# UNITED STATES PATENT AND TRADEMARK OFFICE

APPLICATION NO.	FILING DATE	FIRST NAMED INVENTOR	ATTORNEY DOCKET NO.	CONFIRMATION NO.
09/678,414	10/02/2000	David W. Carlson	100-13604	4381
33402 7590 05/15/2007 LAW OFFICES OF MARK C. PICKERING P.O. BOX 300 PETALUMA, CA 94953			EXAMINER KEBEDE, BROOK	
			ART UNIT 2823	PAPER NUMBER
			MAIL DATE 05/15/2007	DELIVERY MODE PAPER

**Office Action Summary**

**FIG. 2D**

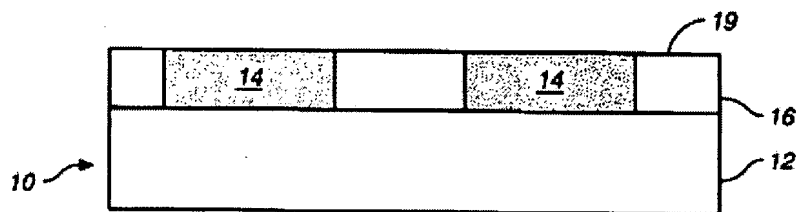
Applicant further argued that "As shown Fig. 2C, Li teaches the native oxide layer 18, *the second material*, has been removed, from polysilicon 16, the first material, but Li totally fail to teach or suggest that the polishing continues until substantially all the native oxide layer 18 has been removed at which time polysilicon layer 16 has a substantial planar top surface as required by claims..."

In response to the applicant's argument, it is respectfully submitted that Li et al. '368 disclose all the claimed limitations the instant application as claimed in claims 31-36, 38-46 and 49-52 as applied above. For example, as shown in Fig. 2D and presented herein below, the first material layer 16 does actually polished to have planar surface prior layer 50b, 106 and 104 are deposited. The removal of the second material layer 18 and planarizing of the second material 16 is happened concurrently within short period of time by CMP process (see also Col. 6, lines 1-5). In addition, with respect to applicant's argument, it is not clear how could be possible that polishing of layer 16 with out removing of layer 18.

**FIG. 2G**

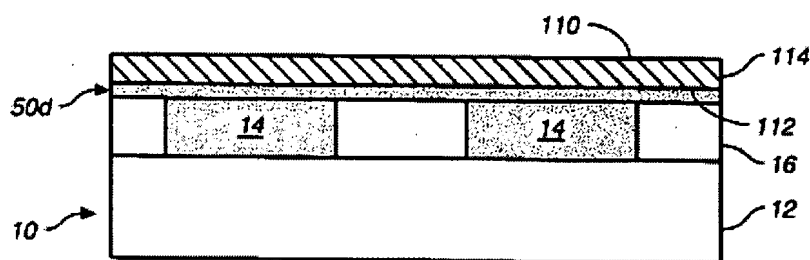
After the CMP process and removal of the material layer 18, the first material layer 16 having a substantially planar surface 19 as shown in Fig. 2G herein below.

Further in response to applicant's contention, it is respectfully submitted the instant application claimed invention does not specifically disclose to the degree of certainty that instant application CMP process will result a perfect planar surface that cannot be achieved by the CMP process of Li et al. '368. There is no evidence can be found in the instant application to the contrary of Li et al. '368 disclosure.
